This submission relates to the route selection process for the Border to Gowrie section of Inland Rail (IR), and proposes that the route selection process was contradictory and based on flawed information.

This submission relates to the flood impacts on the Border to Gowrie (B2G) section of Inland Rail (IR), and proposes that there is huge environmental risk, particularly to the fragile black vertosols and agricultural practice and profitability on the fertile Condamine floodplain. In parallel, it also documents the engagement and consultation process with ARTC surrounding flood modelling and impacts.

This submission relates to the project rationale for improved access to regional markets in the Border to Gowrie section of Inland Rail (IR), and proposes that the business case is misleading and based on flawed information.

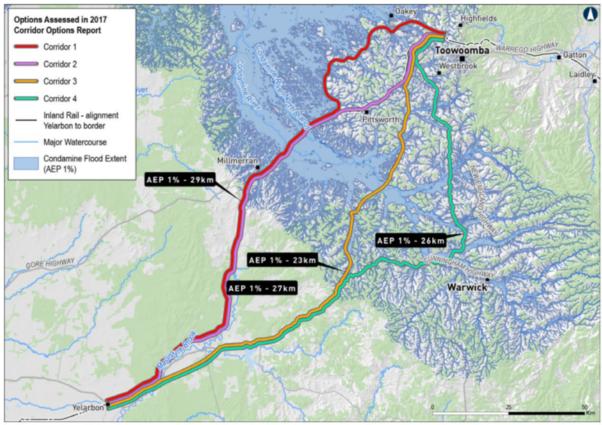
This independent assessment was the same process undertaken by the Program Reference Group (PRG). However, the PRG process was undertaken by FFJV Engineers and ARTC, and thus did not provide an assessment of route selection that was independent of the IR project. We propose that the SMEC report would have been more objective as it was undertaken by an independent panel of advisors.
